Index 711-003 Interchange Markings

COMMENTARY

COMMENTS AND RESPONSES

SINGLE-LANE PARALLEL-TYPE ENTRANCE WITHOUT ADDED LANE

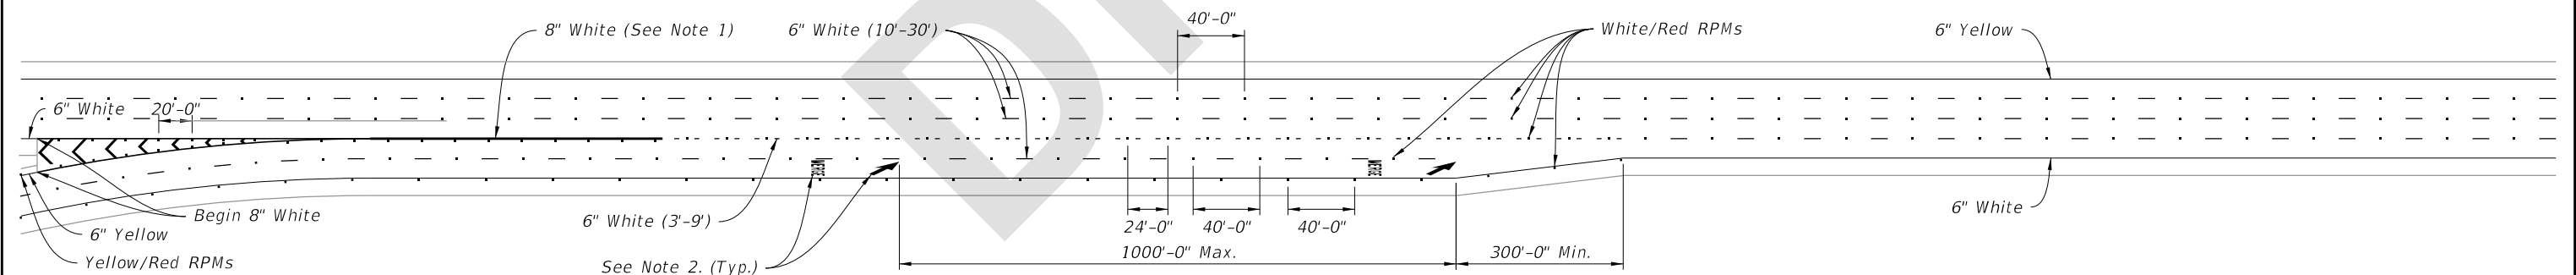
COMMENT: Is the new detail (SINGLE-LANE PARALLEL-TYPE ENTRANCE WITHOUT ADDED LANE) missing "MERGE" pavement markings?
What is the 1000'-0" measured to?

RESPONSE: Note 3 covers that only the "Two-Lane Entrance" uses the Merge Pavement Message and Arrow.

The 1000' Dimension in the Single-Lane Entrance should be deleted.

CHANGE MADE TO INDEX: Yes. The 1000' Dimension was deleted.
